# 1984 - 1986 Corvette: Service Bulletin: Window Regulators - Replacement

**Number:** REISSUE 86-17

**Subject:** WINDOW REGULATORS

**Model and Year:** 1984-1986 CORVETTE

### WINDOW REGULATOR ASSEMBLY

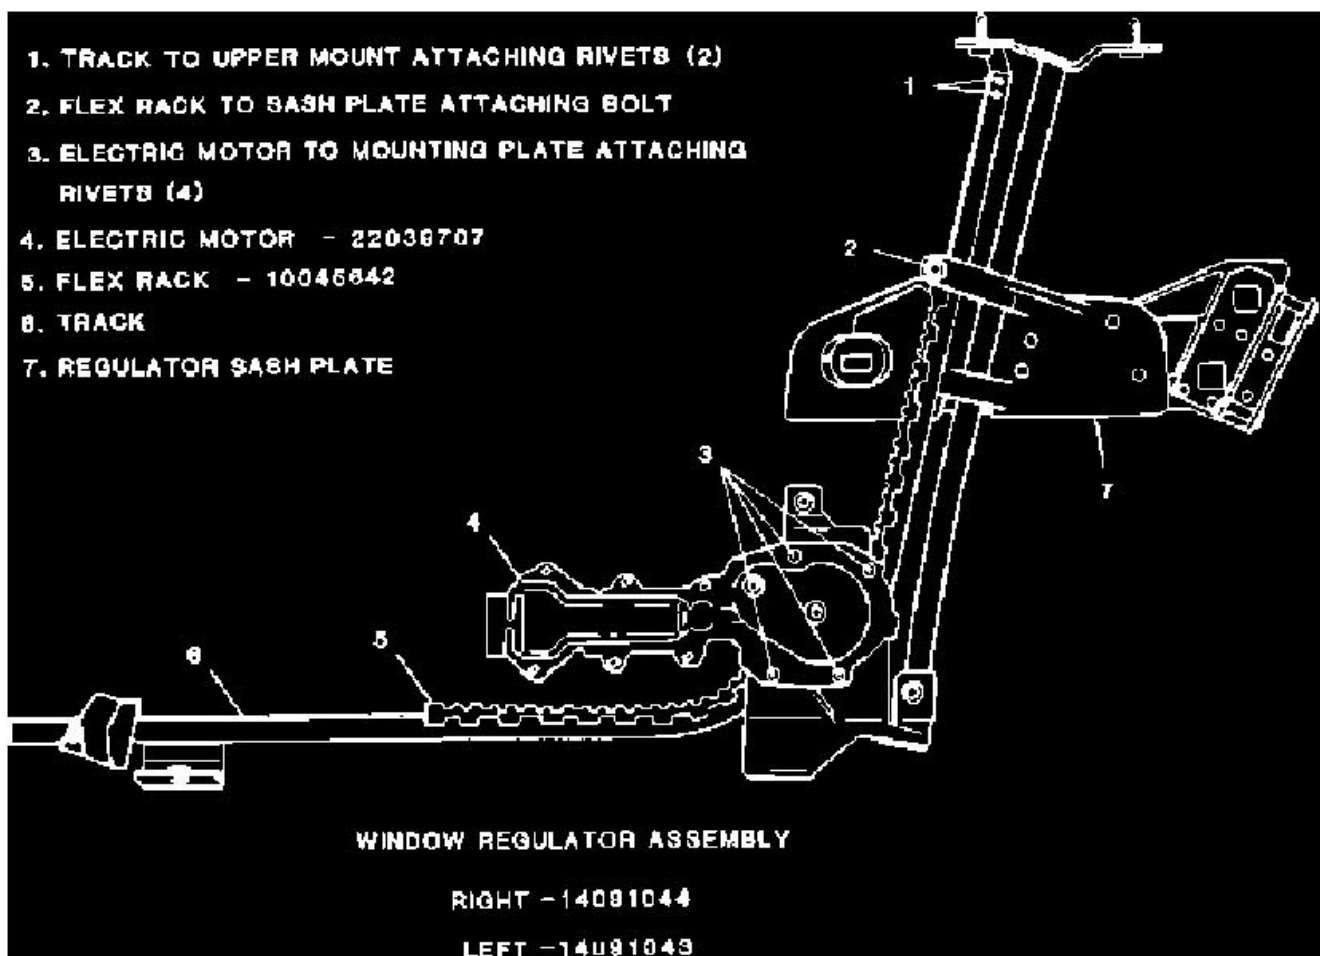
This bulletin contains part numbers and procedures for the replacement of the electric motor and plastic flex rack of the window regulator assembly (Items 4 and 5, Figure 1).

Regulator conditions encountered on vehicles built prior to September, 1984 or that have flex rack tracks which are not chrome, (Item 6, Figure 1) but are yellow or gold in color, or dull metal finish, require replacement of complete regulator assembly.

Conditions encountered on vehicles built after August, 1984 or regulators with chrome flex rack tracks (Item 6, Figure 1) may be repaired with component parts (electric motors and or revised flex racks, Items 4 and 5,

Figure 1).

1. Remove regulator assembly from door and place on a clean work surface.
2. Using an electric drill. motor and 4mm (5/32") drill bit, drill out four (4) attaching rivets that retain the electric window motor to the 1986 Chevrolet Corvette V8-350 5.7L Copyright © 2006, ALLDATA 8.80 Page 2 lower mounting place (location 3, Figure 1).

3. Remove the motor from the regulator assembly and transfer the plastic drive gear to the new motor.
4. Clean the lower mounting plate of all metal shavings prior to motor installation.

5. Apply lubricant (GM P/N 1052349 or equivalent) to the drive gear, flex rack, track and gear housing on the lower mounting plate.
6. Install the new motor to the mounting plate using four (4) 4 mm X 10 mm (5/32" X 3/8") rivets (location 3, Figure 1).

2. Using an electric drill motor and 4mm (5/32") drill bit, drill out the two (2) track to upper mounting plate attaching rivets (location 1, Figure 1).

3. Remove the Allen head type bolt (location 2, Figure 1) retaining the flex rack to the regulator sash plate. It will be necessary to hold the attachment nut on the underside of the sash plate to prevent it from rotating.

4. Lift track away from upper mounting plate and carefully pull track away from guide tube in order to disengage the flex rack and track from the sash plate opening at location 2, Figure 1.

9. Locate the flex rack and track into the sash plate opening at location 2, Figure 1. Apply Loctite Thread Sealer to the bolt threads prior to reinstalling the Allen type bolt at location 2, Figure 1 to prevent loosening from vibration.

10. Locate and fasten track to the upper mounting plate using two (2) 4mm X 10mm (5/32" X 3/8") rivets (location 1, Figure 1).
11. Using an external power source, operate the regulator to insure quiet, free operation.
